Change Order #2

Regional Linear Park Phase II
(Hike & Bike Trail)

Project: RLPPII
Contract: C-18-199-02-12
CSJ: 0921-02-409
Limits: Hall Acres to Ridge Road

Change Order #2 introduces additional cost and work to re-establish drainage on Cage Blvd. (US 281) after installing a 12x8 pedestrian tunnel for this project.

REGIONAL LINEAR PARK PROJECT
PLAN & PROFILE (LEG 1)
STA. 121+00 TO STA. 127+00

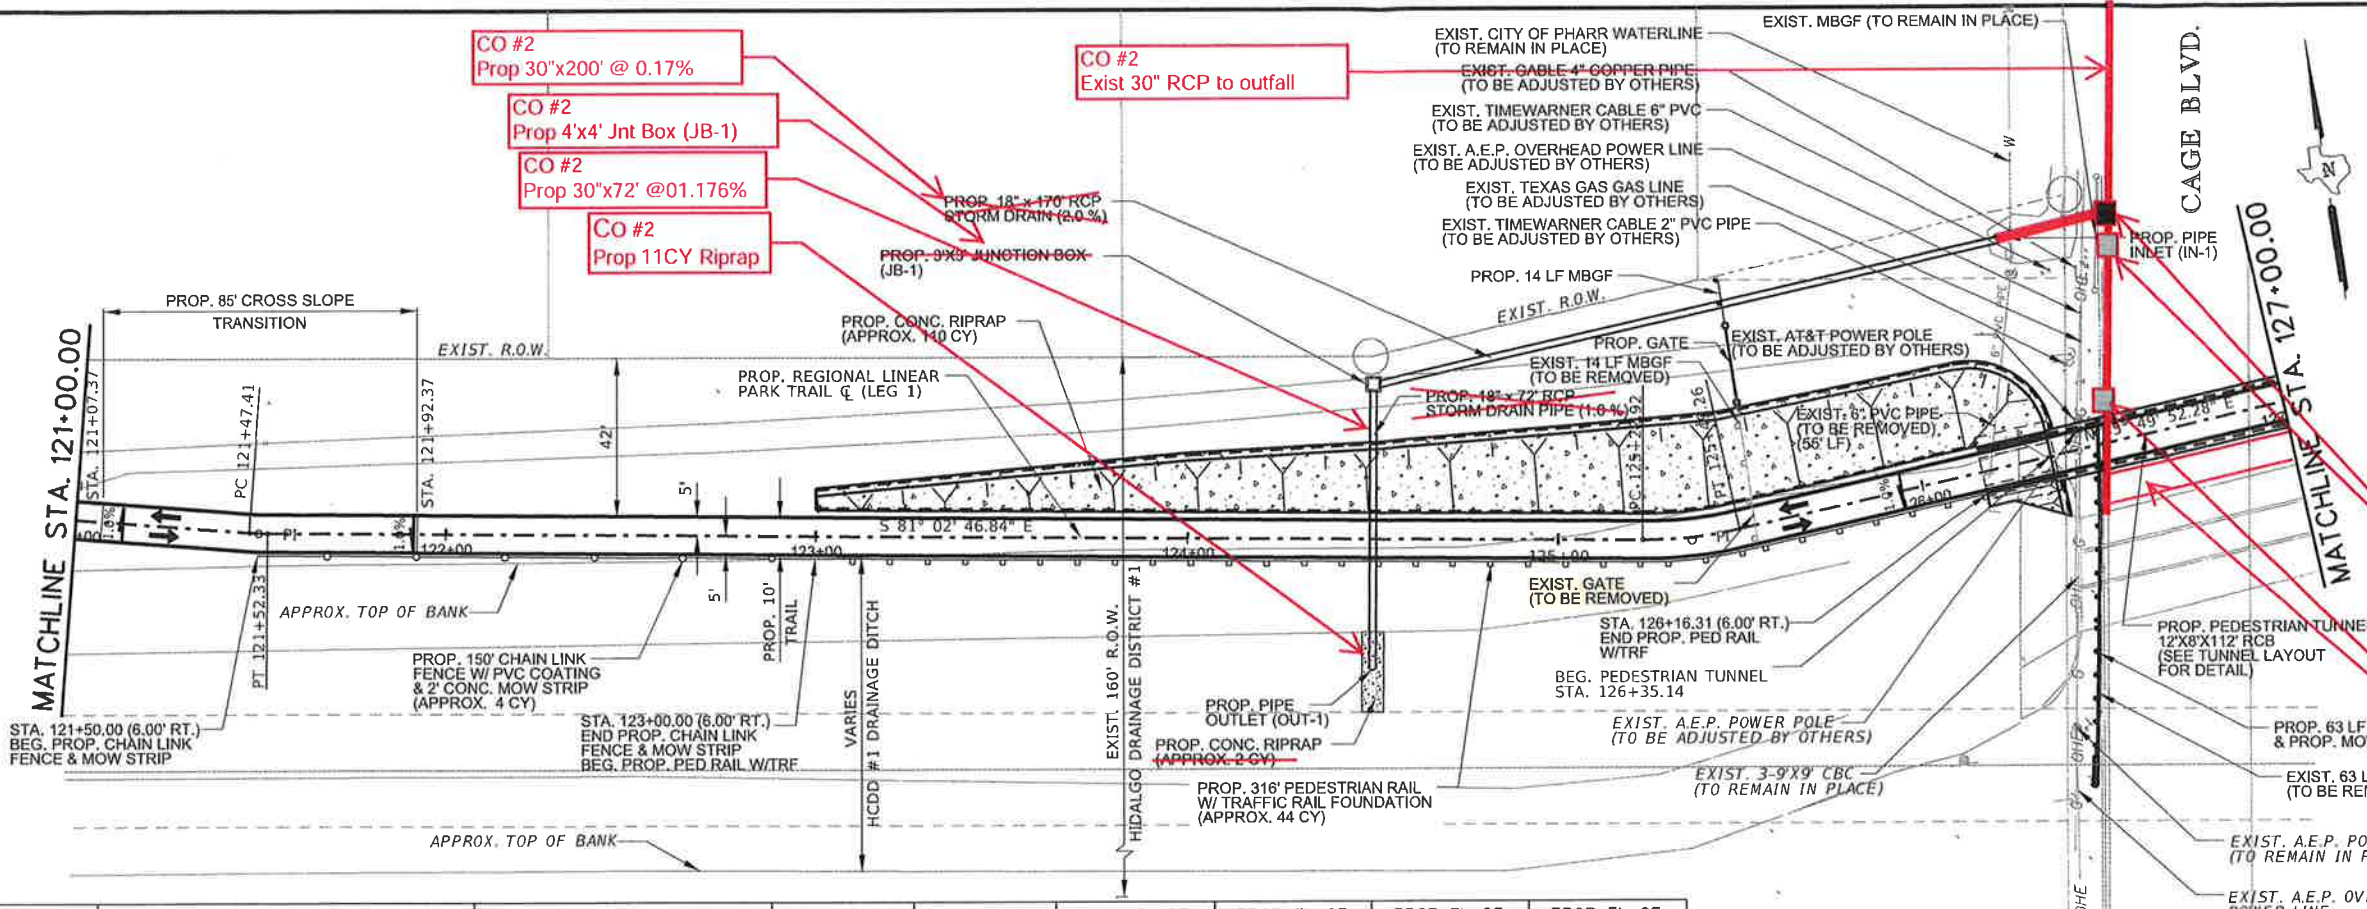
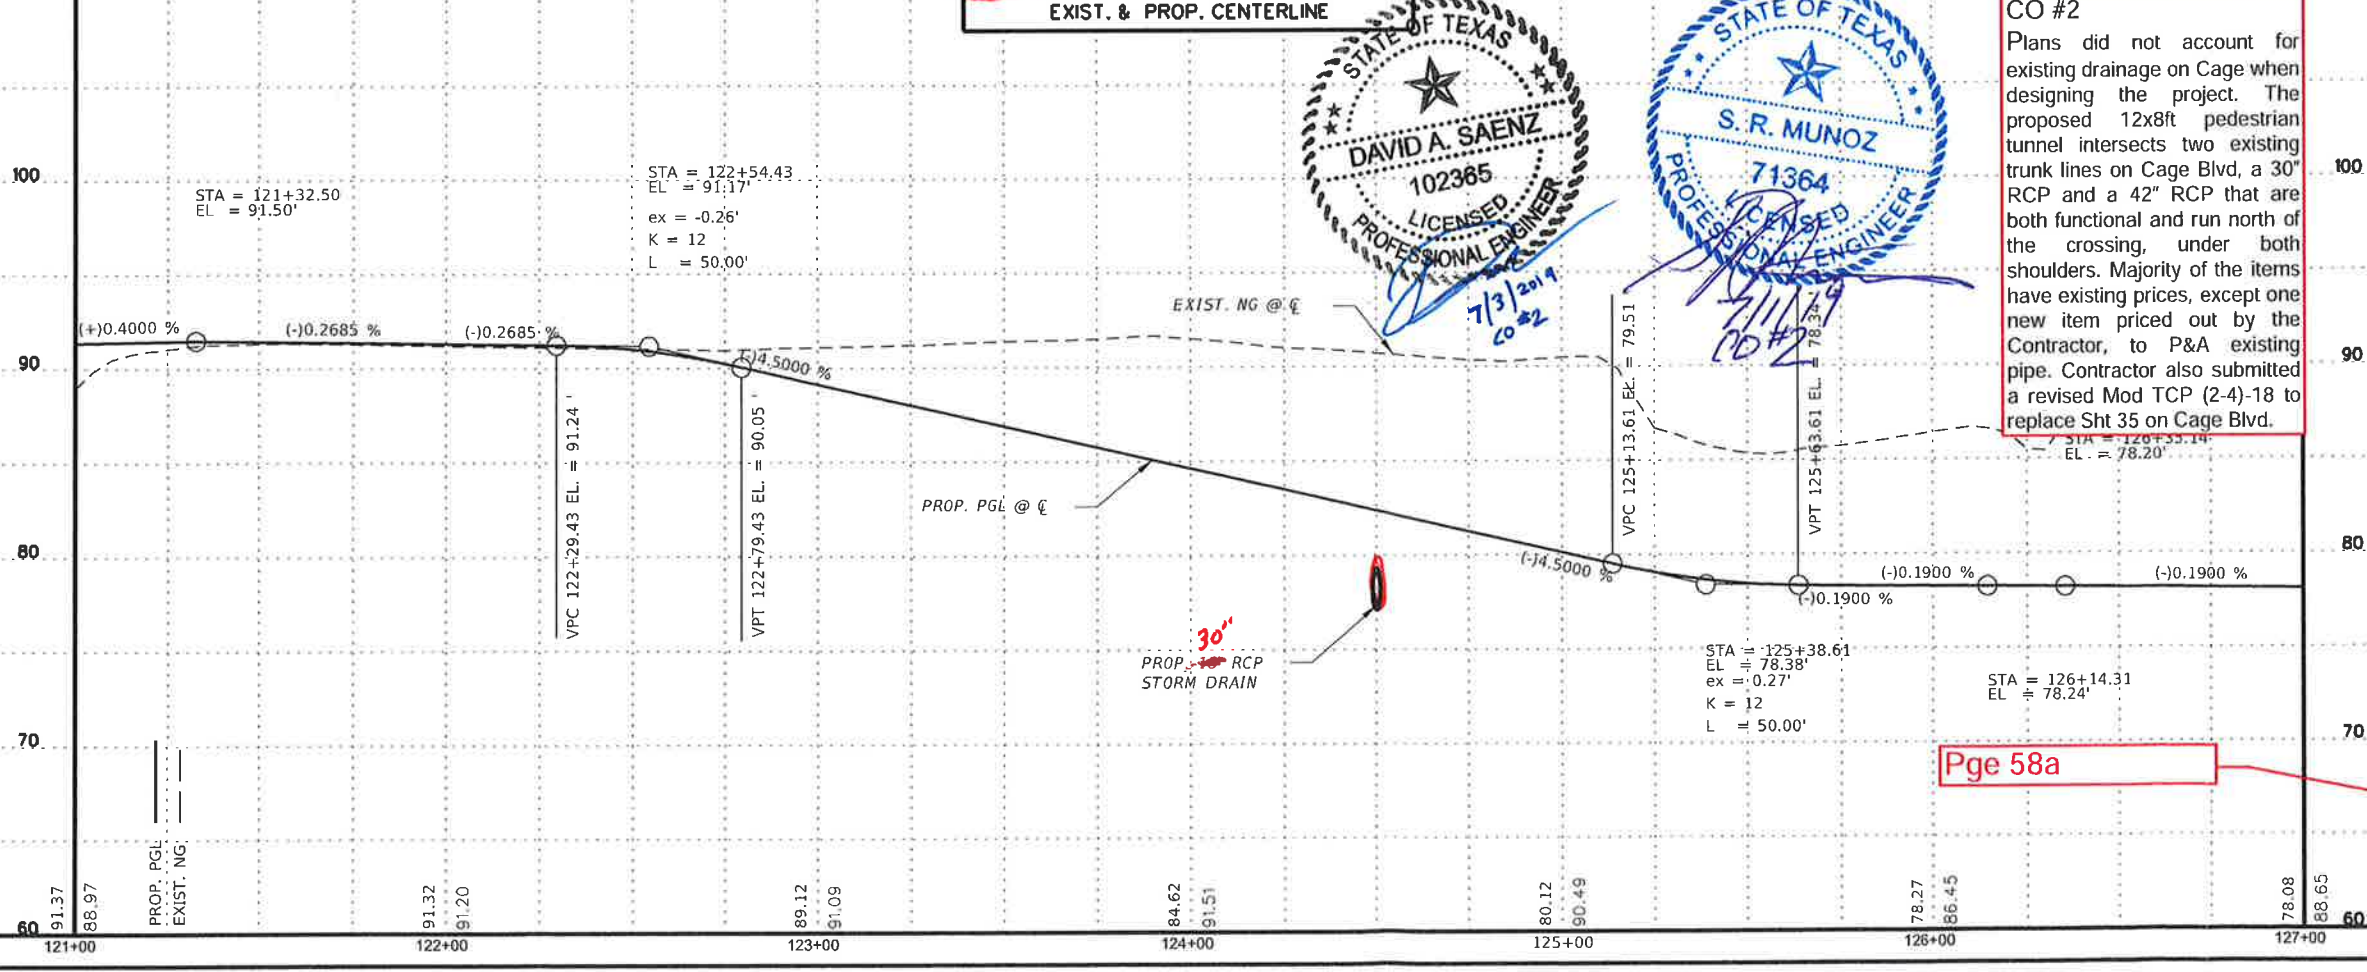
- CO #2
Connect 48" RCP to outfall
Prop 6'x6' Jnt Box (JB)
Plug Ex. 42" RCP
- CO #2
Rem 60" RCP x 100'
Rem 42" RCP x 20'
Plug Ex. 42" RCP

CO #2
Plans did not account for existing drainage on Cage when designing the project. The proposed 12x8ft pedestrian tunnel intersects two existing trunk lines on Cage Blvd, a 30" RCP and a 42" RCP that are both functional and run north of the crossing, under both shoulders. Majority of the items have existing prices, except one new item priced out by the Contractor, to P&A existing pipe. Contractor also submitted a revised Mod TCP (2-4)-18 to replace Sht 35 on Cage Blvd.

REGIONAL LINEAR PARK PROJECT
 US 281 (S. CAGE RD.)
 DETOUR LAYOUT

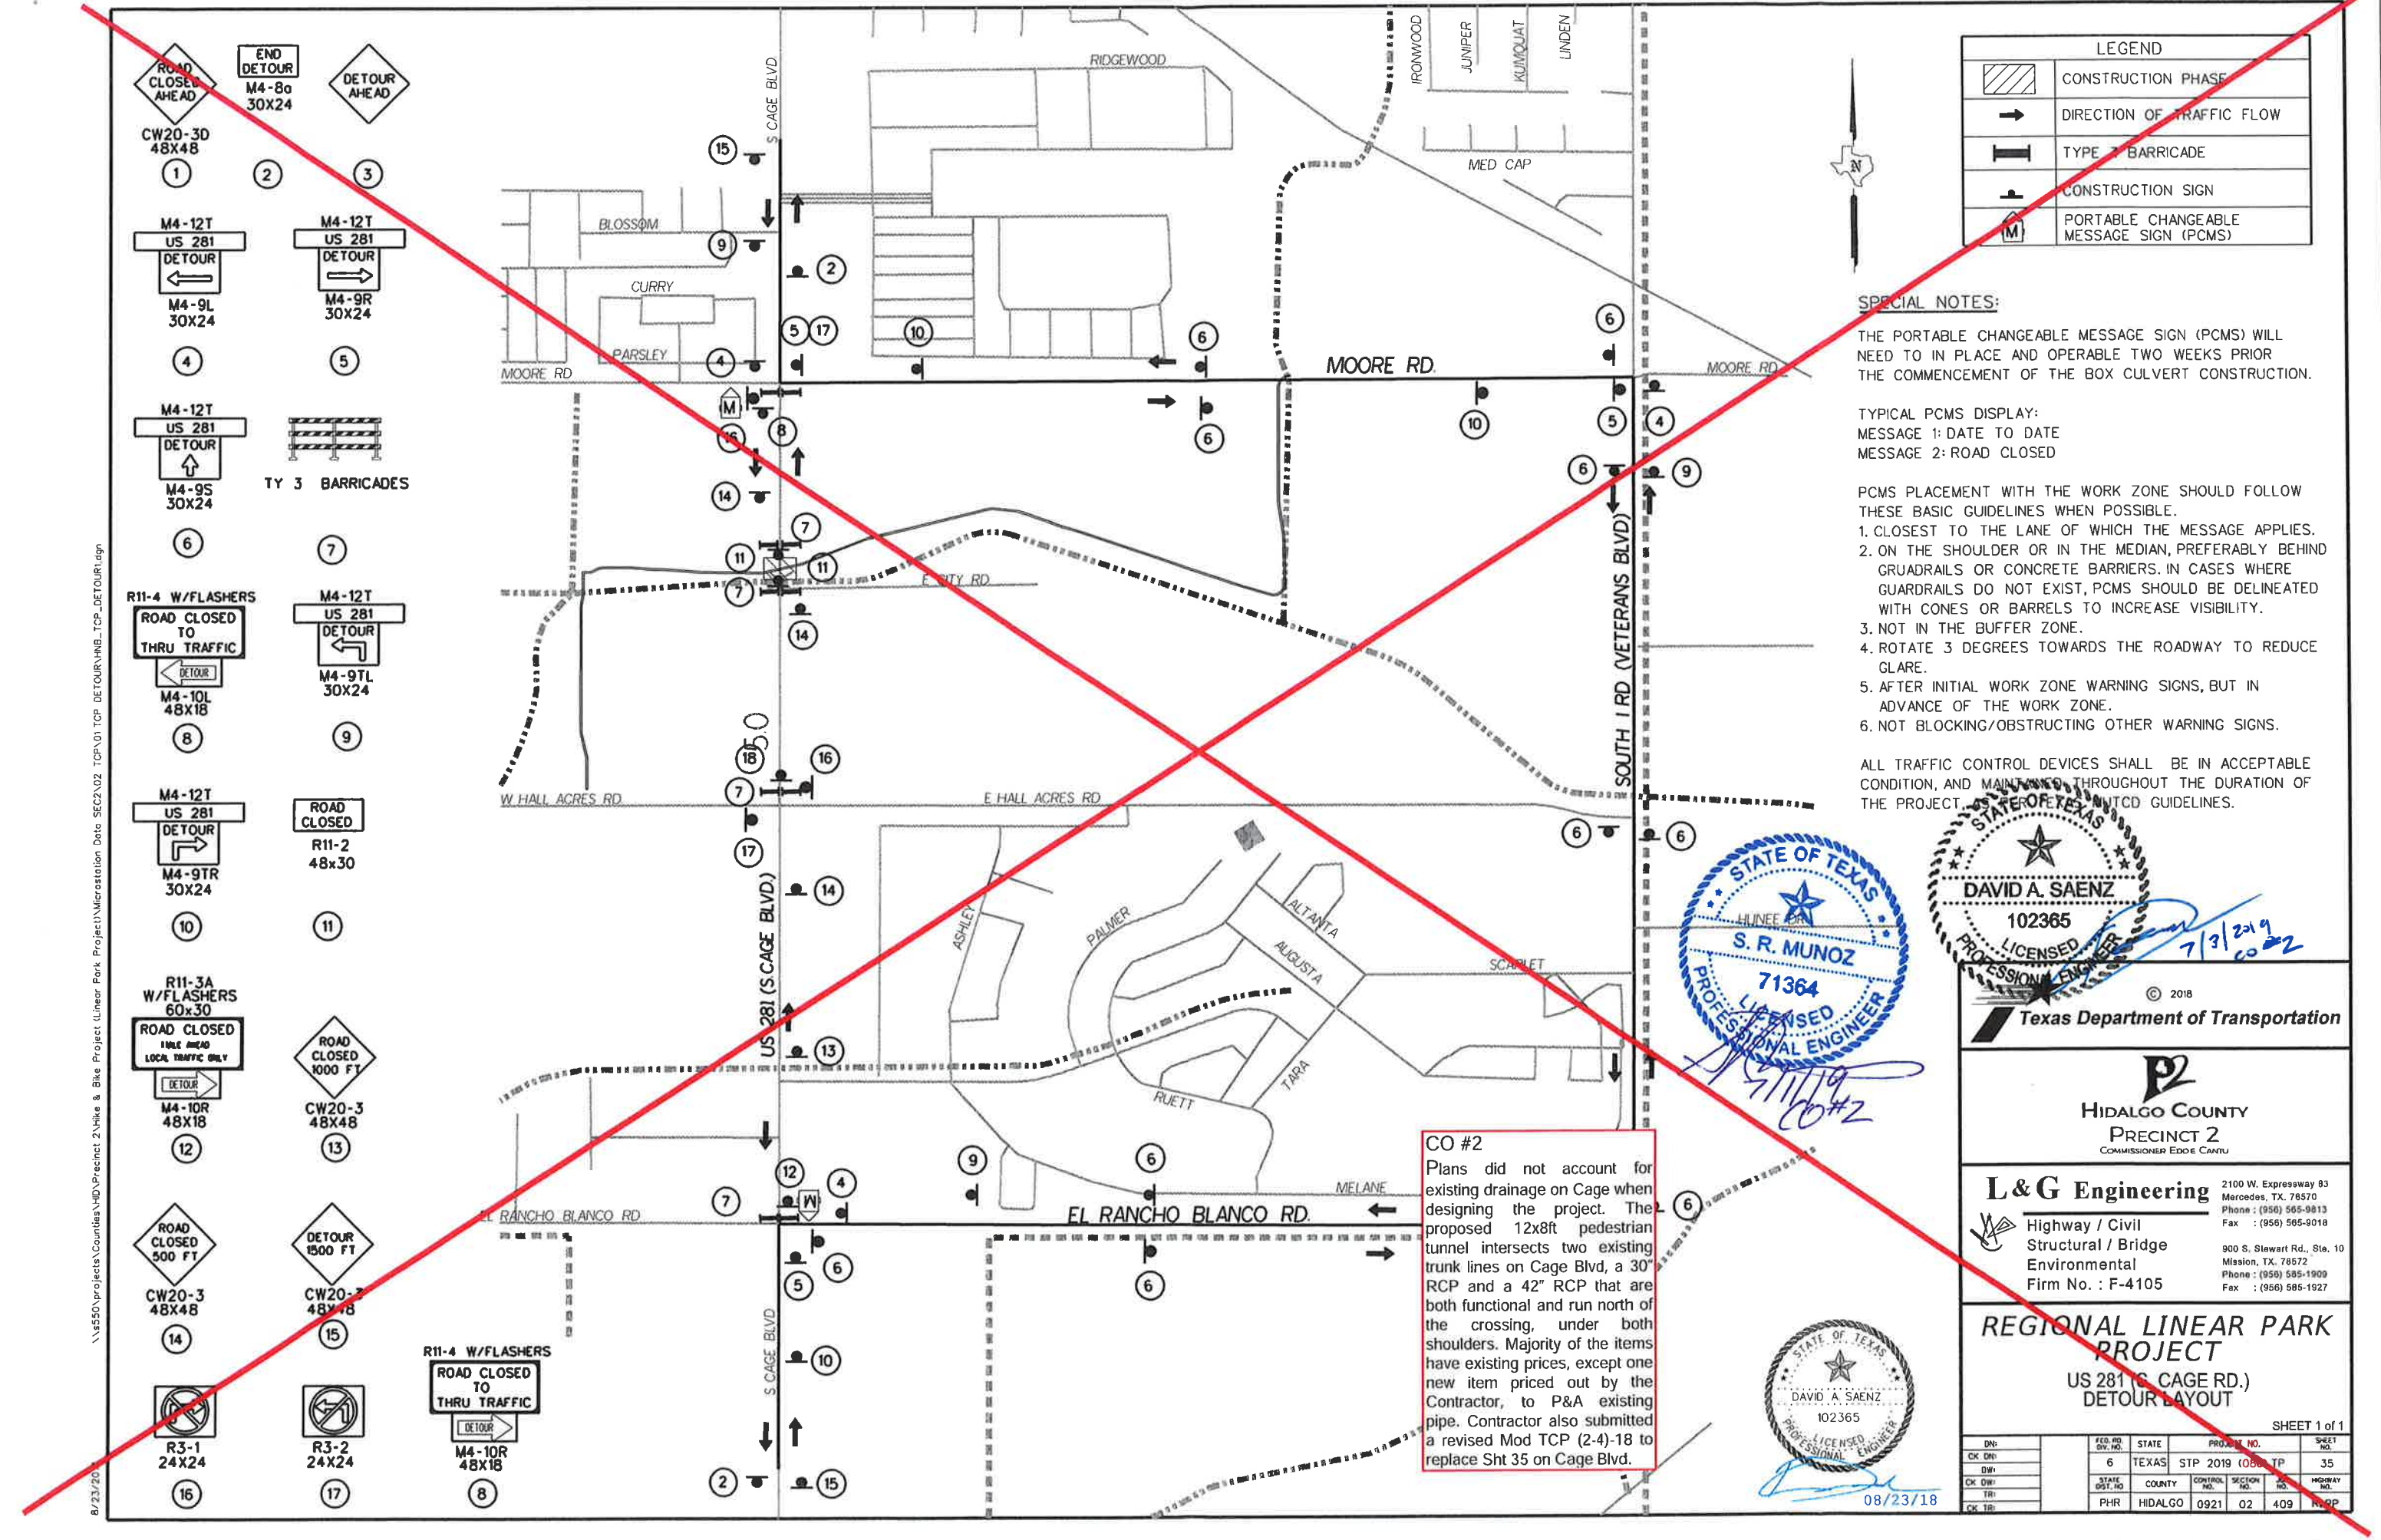
CO #2
 Plans did not account for existing drainage on Cage when designing the project. The proposed 12x8ft pedestrian tunnel intersects two existing trunk lines on Cage Blvd, a 30" RCP and a 42" RCP that are both functional and run north of the crossing, under both shoulders. Majority of the items have existing prices, except one new item priced out by the Contractor, to P&A existing pipe. Contractor also submitted a revised Mod TCP (2-4)-18 to replace Sht 35 on Cage Blvd.

MOD TCP(2-4)-18

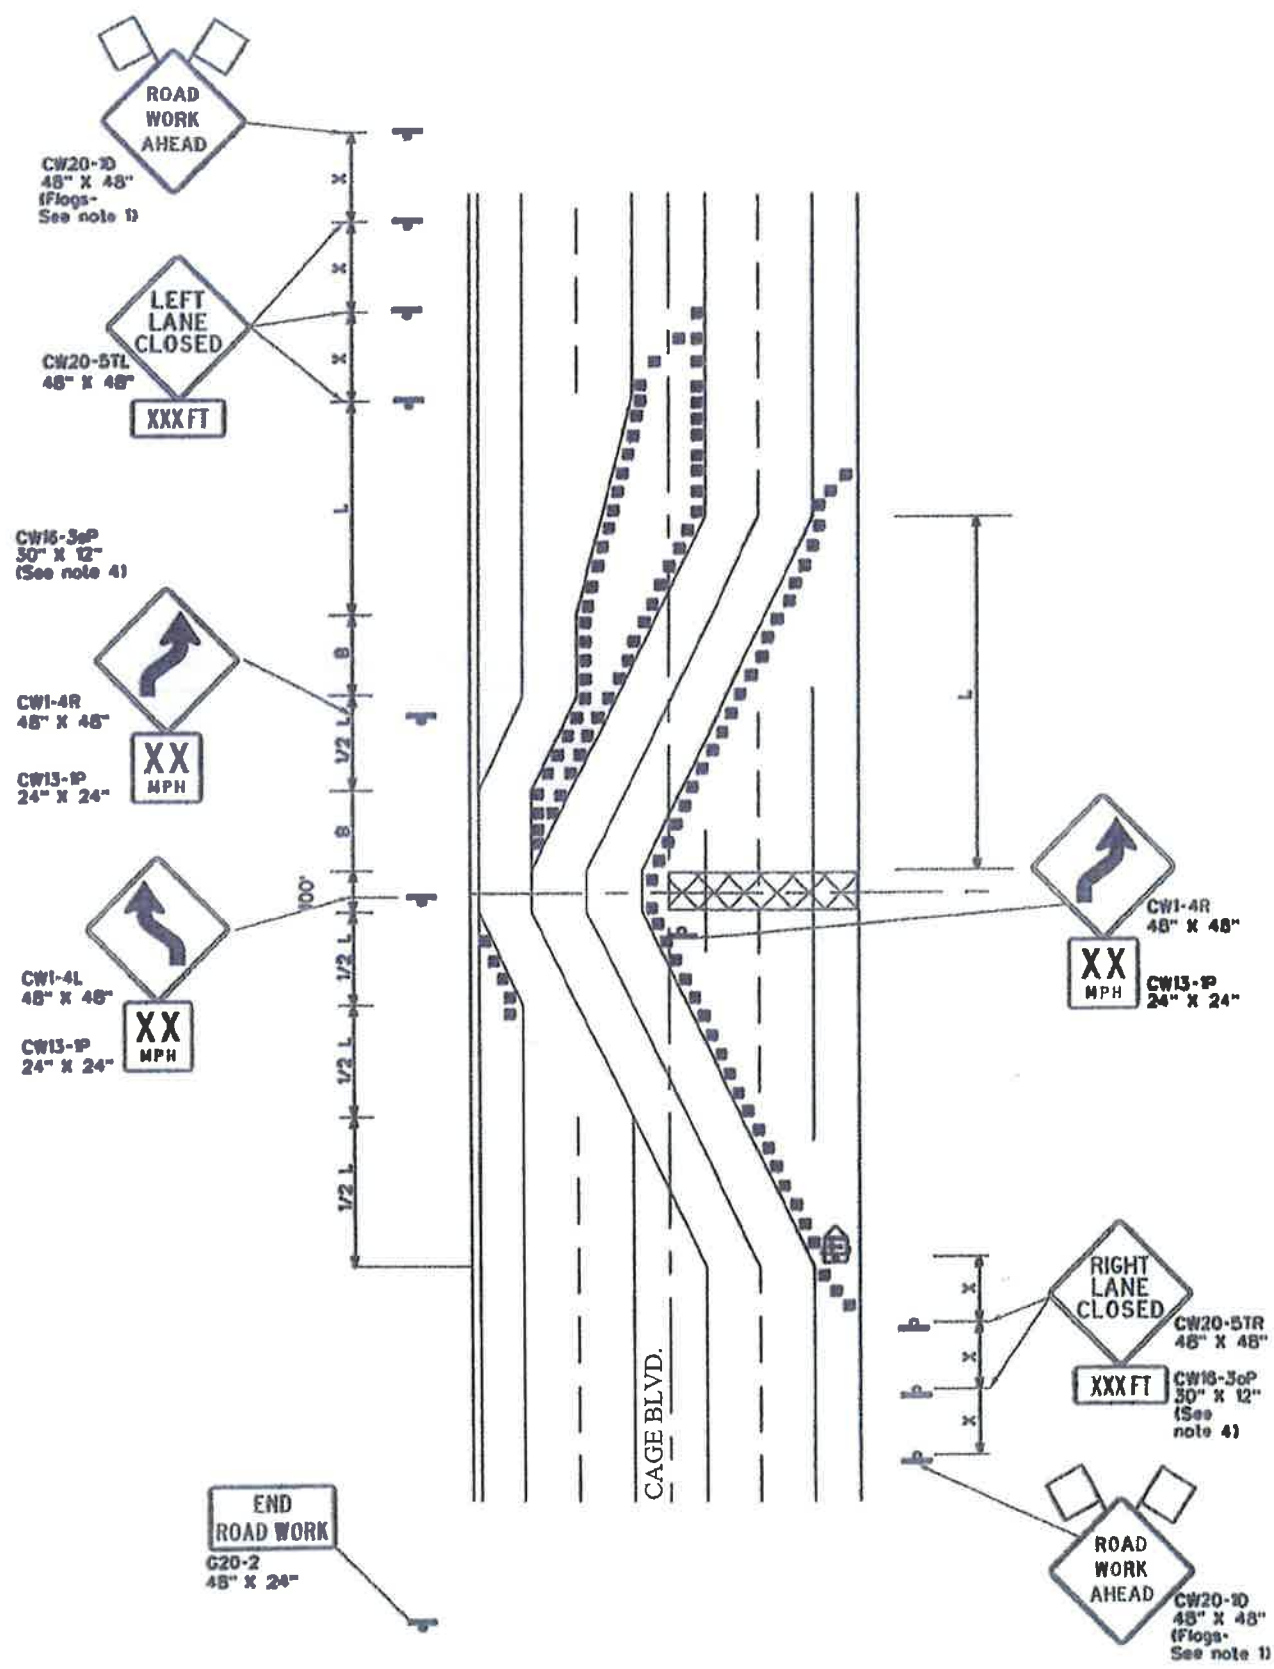
CO #2
 Plans did not account for existing drainage on Cage when designing the project. The proposed 12x8ft pedestrian tunnel intersects two existing trunk lines on Cage Blvd, a 30" RCP and a 42" RCP that are both functional and run north of the crossing, under both shoulders. Majority of the items have existing prices, except one new item priced out by the Contractor, to P&A existing pipe. Contractor also submitted a revised Mod TCP (2-4)-18 to replace Sht 35 on Cage Blvd.

Y. Corbett, PE
 5/24/2019
 CO#2
